# Service Information

Category <b>S</b>	<b>Repair Guidance</b>	Ref. No. R038/08	Page 1 of 2
Coverage <input type="checkbox"/> Distributor only <input checked="" type="checkbox"/> Please inform your dealers		Date Issued April 24, 2008	
Please convey this information to your <input type="checkbox"/> Director <input checked="" type="checkbox"/> General Manager <input checked="" type="checkbox"/> Warranty Dept. <input checked="" type="checkbox"/> Parts Dept. <input checked="" type="checkbox"/> Training Dept. <input checked="" type="checkbox"/> Field Rep.		Date Revised October 23, 2008	
Applicable Model  RX-8 (FE/SE)		Applicable Countries or Specifications  Worldwide

## Subject: Unusual Noise from Front of Vehicle / Front Stabilizer Control Link Breakage

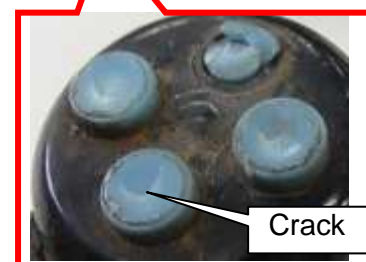
Some vehicles may exhibit an unusual noise from the front side of the vehicle.

The plastic part connecting the stabilizer control link ball joint to the link is broken apart. As a result, the front lower arm and stabilizer bar are not connected.

Due to excessive impact, the swaying friction of the ball joint increases momentarily and the ball seat receives the load. After this has been repeated some times, a fatigue breakage is caused on the caulking part of the ball joint.

The front control link has been changed to the low friction type.

When you encounter a customer complaint on this concern, replace the front control links with service ones.
